[State Clearinghouse No. 2008121080]

## **Los Angeles International Airport (LAX) Bradley West Project**

## **Responses to Comments and Corrections and Additions to the Draft EIR**

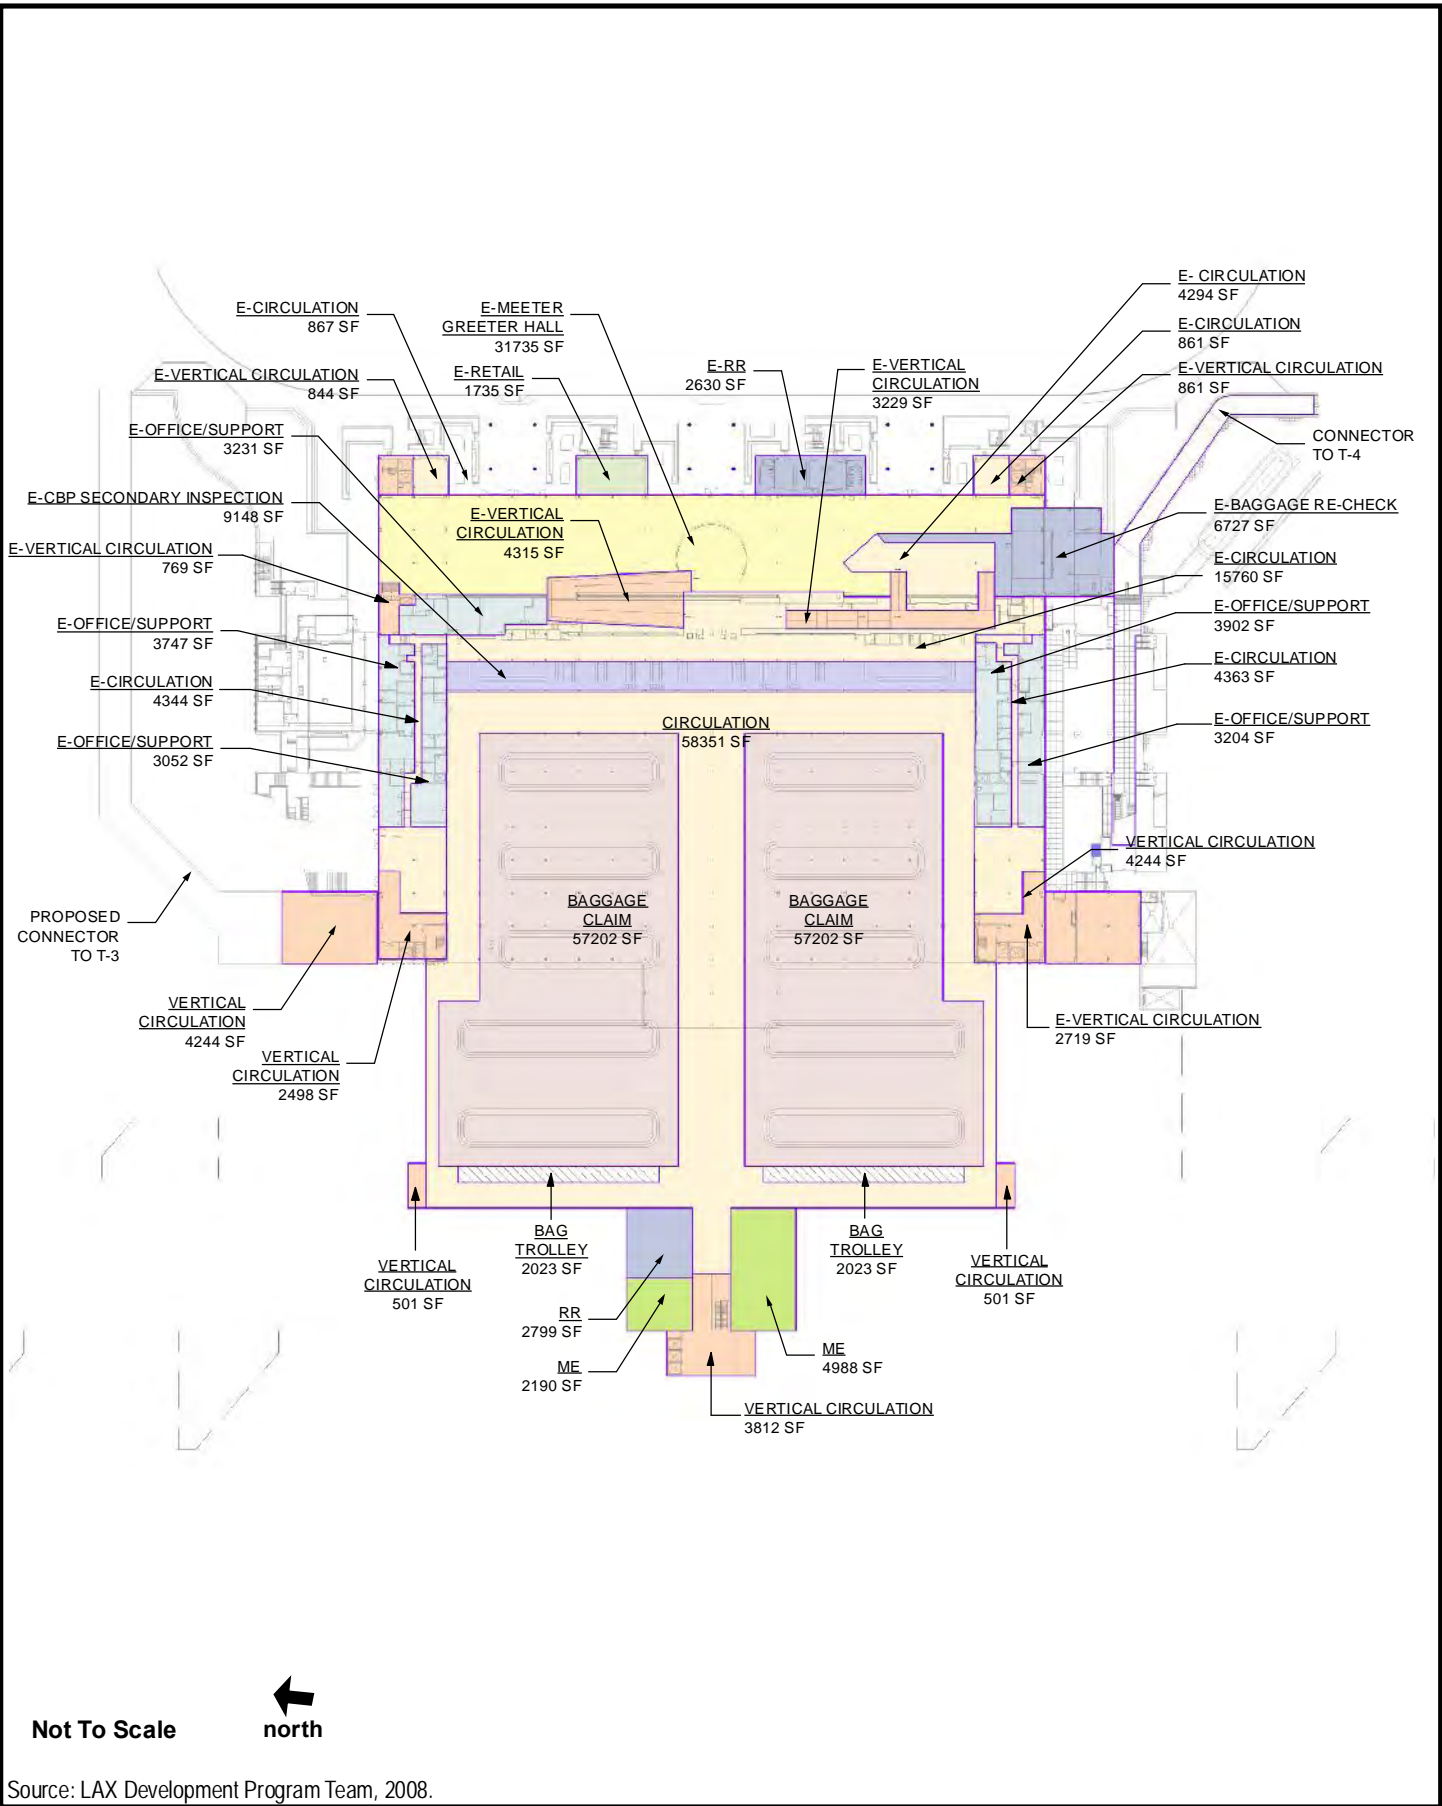
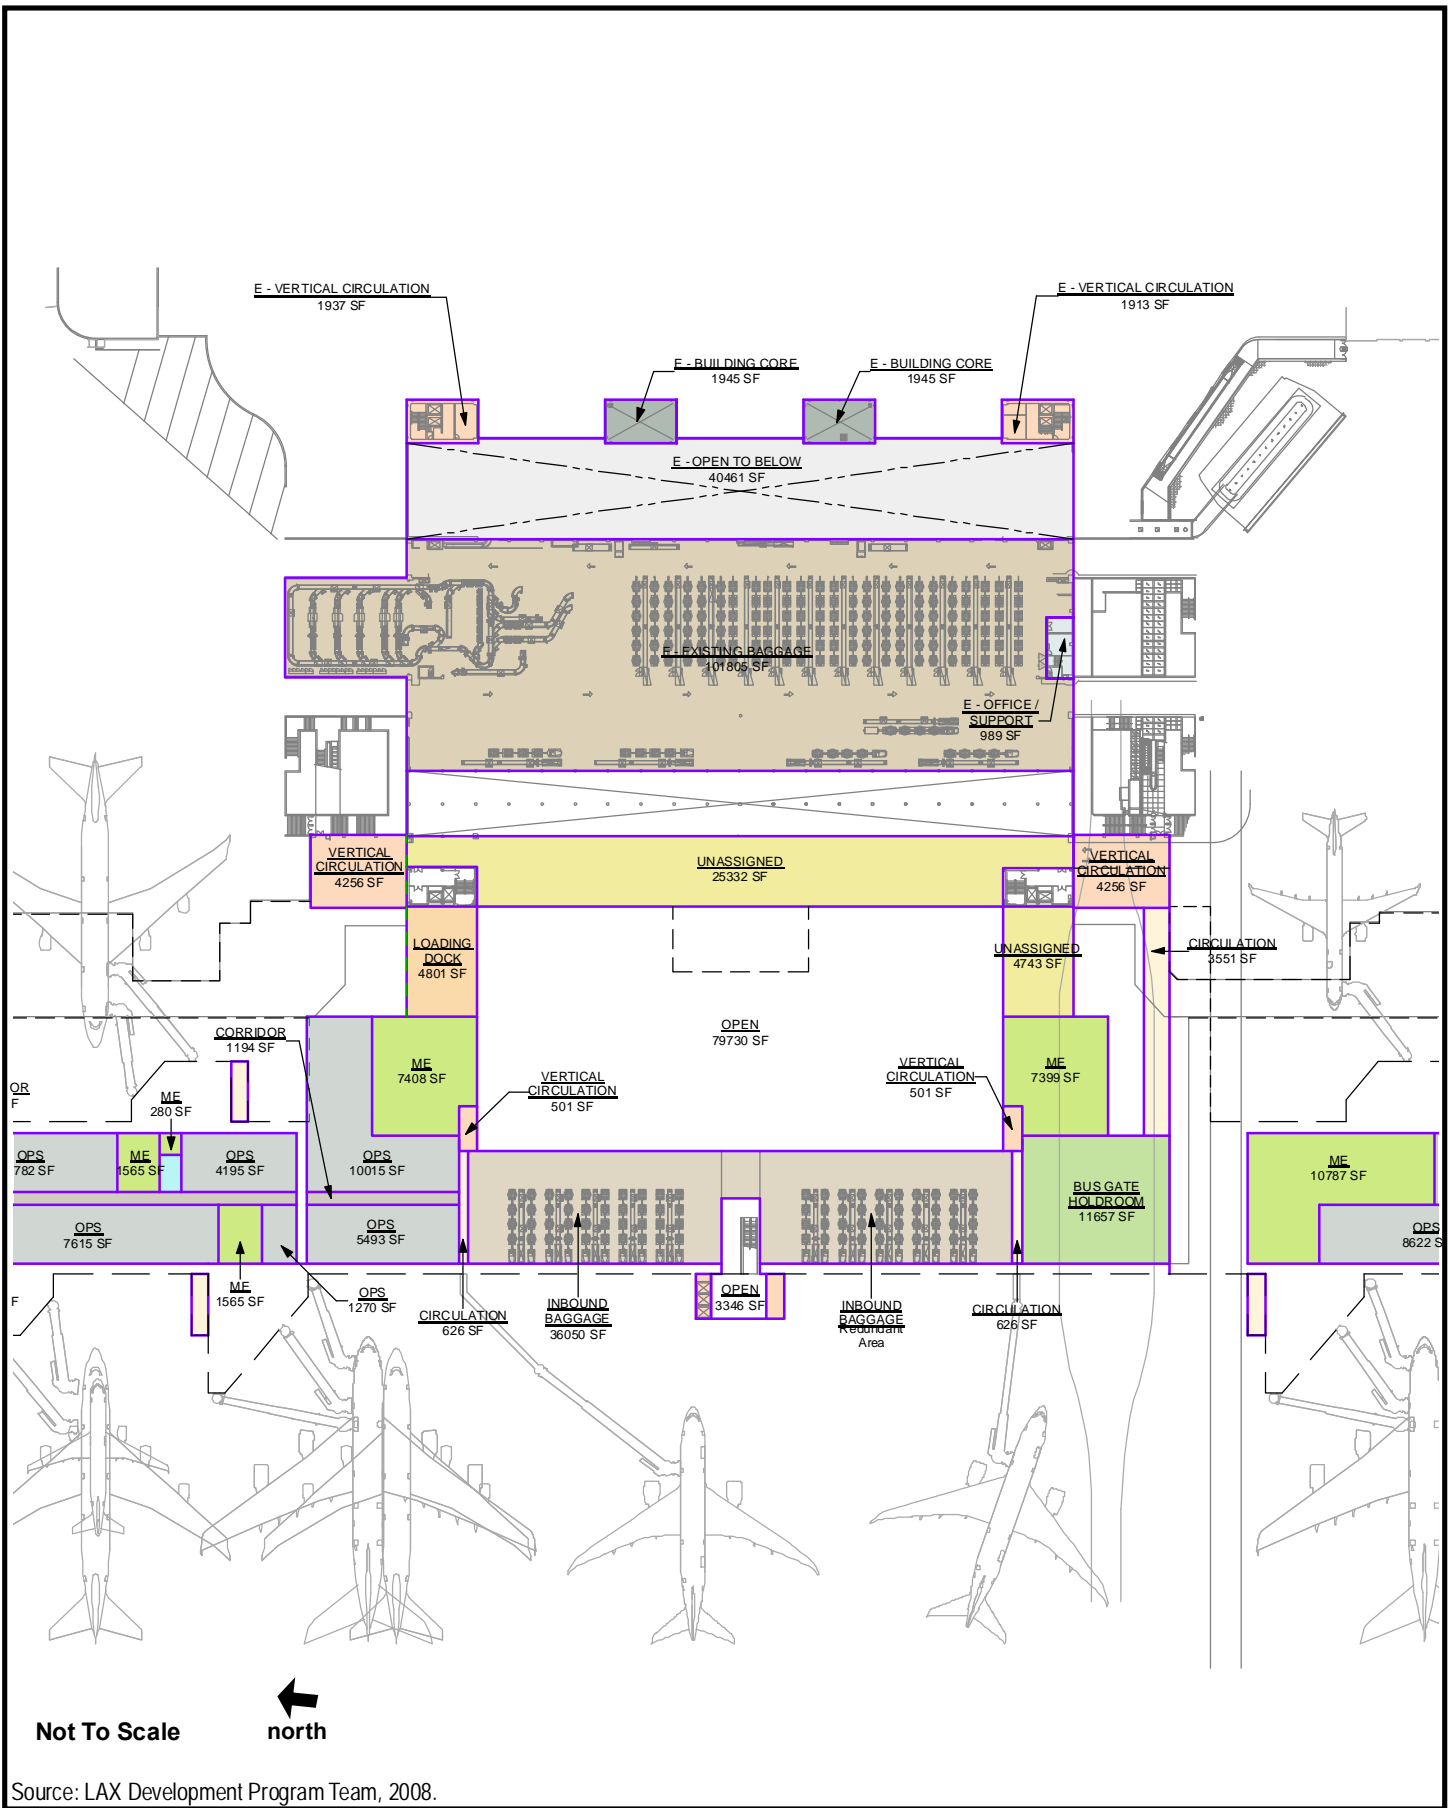
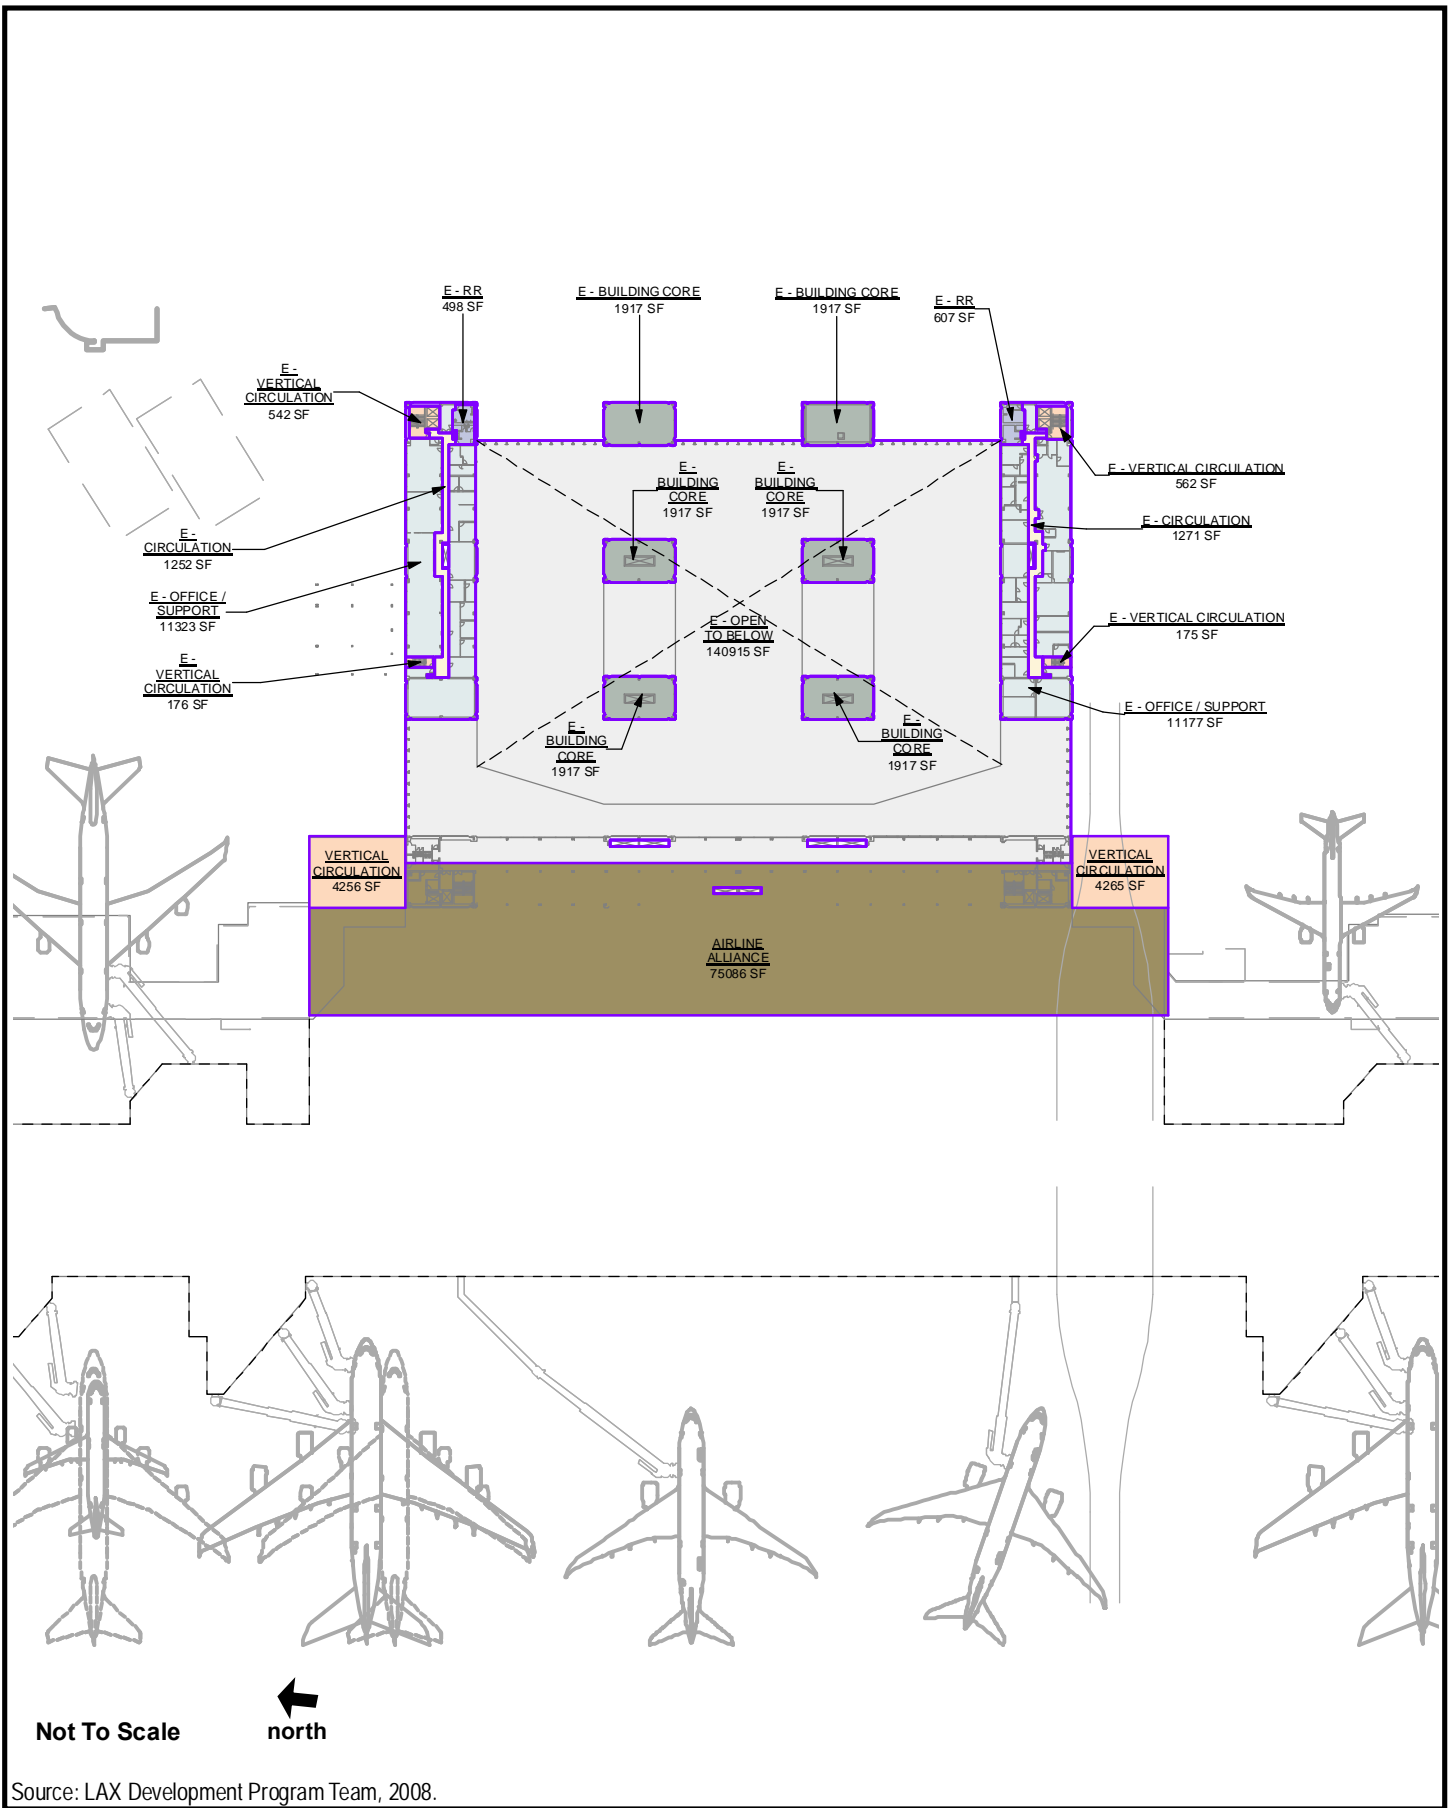
**Comment:** Figure 2.4a floor plan not readable.  
Bradley West Core drawings are not readable.

**Response:** The comment is noted. To increase legibility, the following provides enlargements of the Bradley West Core areas depicted in Figures 2-4a through 2-4e of the Bradley West Project Draft EIR. In addition, a section view of the Bradley West Core, as included in Figure 2-5 of the Bradley West Project Draft EIR, with legible call-outs for certain uses added, is provided below.
